भारत-सरकार/Government of India
रेल मंत्रालय/Ministry of Railways
दक्षिण मध्य रेलवे/South Central Railway

संख्या/No.77/2/P/Earth(T).

Technical Circular No.05/2022

Sub:- Provision of earth electrodes for equipments like CLS control panels,
service buildings, DG sets, water coolers, lifts and escalators etc.

Drawing No.ETI-OHE-P-7021;

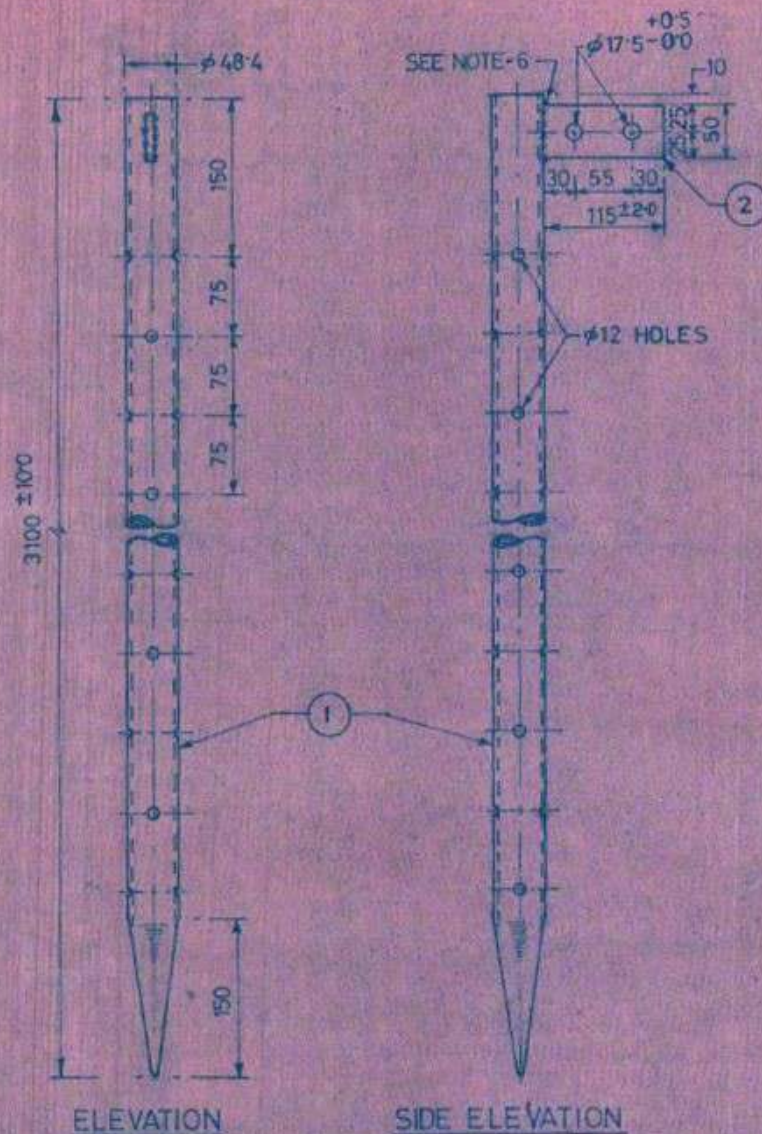
At present for power maintenance equipments earthing in following SCR Drawing No.SK.No.A3/10/M/R is used. As the earth electrode given in drawing is not as per CPWD specification or CORE/ALD specification decided that the above SCR drawing is withdrawn with immediate effect. For good quality electrodes, the following specification & drawing of CORE/ALD shall be used for all feature stores/works procurement. At locations other than sub-station.

Specification No.TI_LKO(PSI/38/2020 Dt.235/08/21 or latest. Copy of the drawing and specification is enclosed as Annexure-A & B. For substations earth electrode of 4M length confirming to RDSO drawing ETI/PSI/222-1 & RDSO Spec No.RDSO-TIOLKO(PSI)/38/2020 dated 25/8/21 to be adopted. Copy of Drawing and spec enclosed as Annexure D & B.
